**CITY PLAN COMMISSION****THURSDAY, MAY 16, 2024****FILE NUMBER:** S234-109**SENIOR PLANNER:** Hema Sharma**LOCATION:** Wheatland Road, west of Lancaster Road**DATE FILED:** April 18, 2024**ZONING:** TH-2(A), MF-3(A)**CITY COUNCIL DISTRICT:** 8**SIZE OF REQUEST:** 2.744-acres**APPLICANT/OWNER:** VM Fund I, LLC; Arthur Santa-Maria

**REQUEST:** An application to create three lots ranging in size from 0.058-acre to 1.886-acre from a 2.744-acre tract of land in City Block 7609 and to dedicate a right-of-way on property located on Wheatland Road, west of Lancaster Road.

**UNIVERSITY HILLS ADDITION**

**PRELIMINARY PLAT**

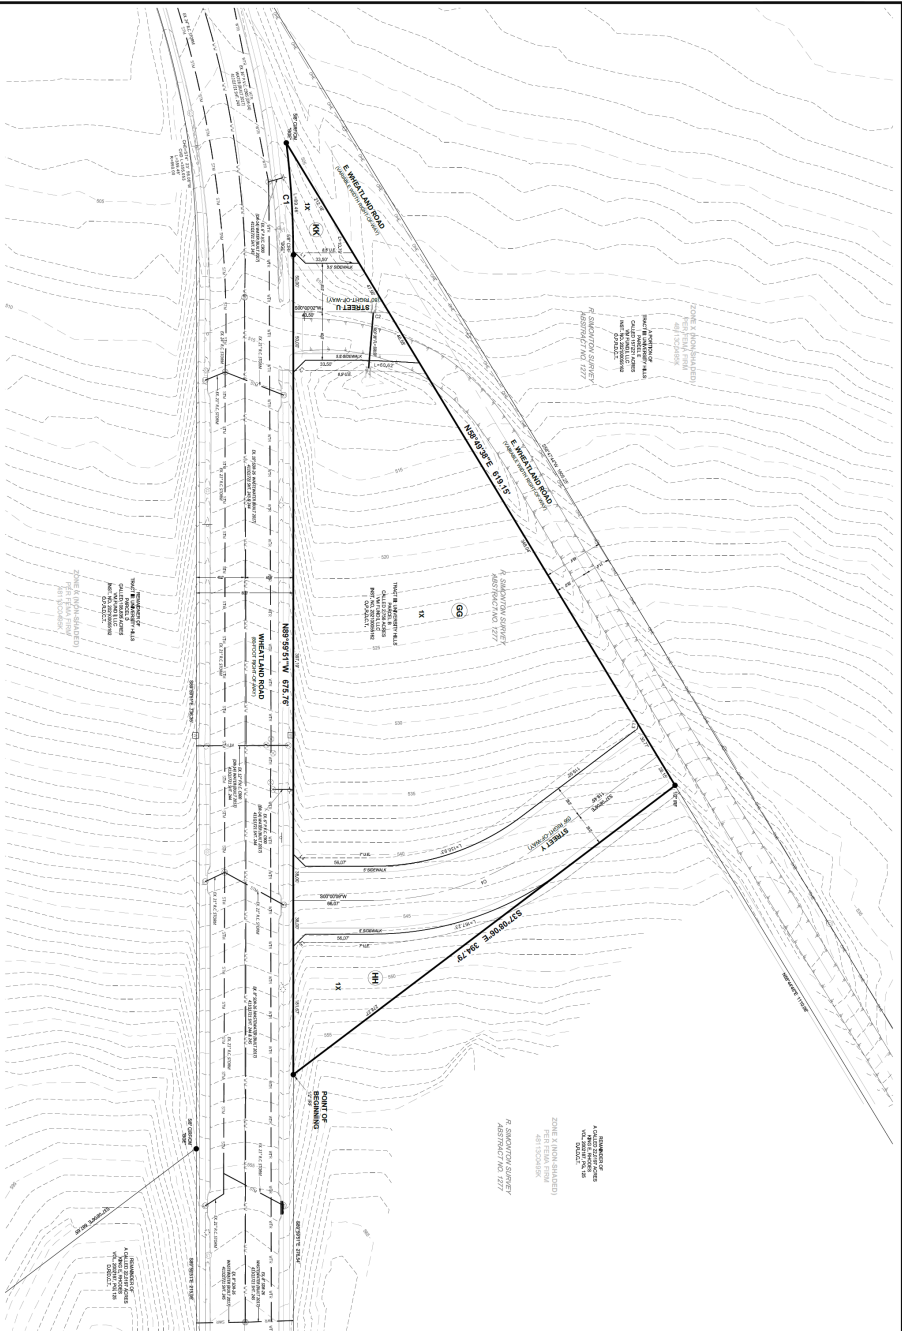
- 15. On the final plat, dedicate 40 feet of right-of-way (via fee simple or street easement) from the established centerline of Wheatland Road. *Sections 51A-8.602(c), 51A-8.604(c) and 51A-8.611(c).*

- 16. On the final plat, dedicate a minimum 5-foot by 5-foot corner clip (via fee simple or street easement) at the intersection of Wheatland Road and Street Y. Section 51A 8.602(d)(1)

- 17. On the final plat, dedicate a minimum 5-foot by 5-foot corner clip (via fee simple or street easement) at the intersection of Wheatland Road and Street Y. Section 51A 8.602(d)(1)

- 18. On the final plat, dedicate a minimum 5-foot by 5-foot corner clip (via fee simple or street easement) at the intersection of Wheatland Road and Street U. Section 51A 8.602(d)(1)

- 21. Prior to final plat, submit a completed final plat checklist and all supporting documents.
- 22. On the final plat, show how all adjoining right-of-way was created. Section 51A-8.403(a)(1)(A)(xxii).
- 23. On the final plat, show distances/width across all adjoining right-of-way
- 24. On the final plat, show recording information on all existing easements within 150 feet of the property.
- 25. On the final plat, show all additions or tracts of land within 150 feet of the property with recording information.
- 26. On the final plat, chose a new or different plat name.

30. Prior to the final plat, please contact Real Estate division regarding right-of-way abandonments.
31. On the final plat, change “E. Wheatland Road” to “Wheatland Road”.
32. On the final plat, add correct Lot and Block information to plat document.
33. Prior to final plat, contact Addressing Team for appropriate names for proposed Row’s-‘Street U” and “Street Y”.
34. On the final plat, identify the property as Lot 1 in City Block G/7609, Lot 1 in City Block H/7609, Lot 1 in City Block J/7609.
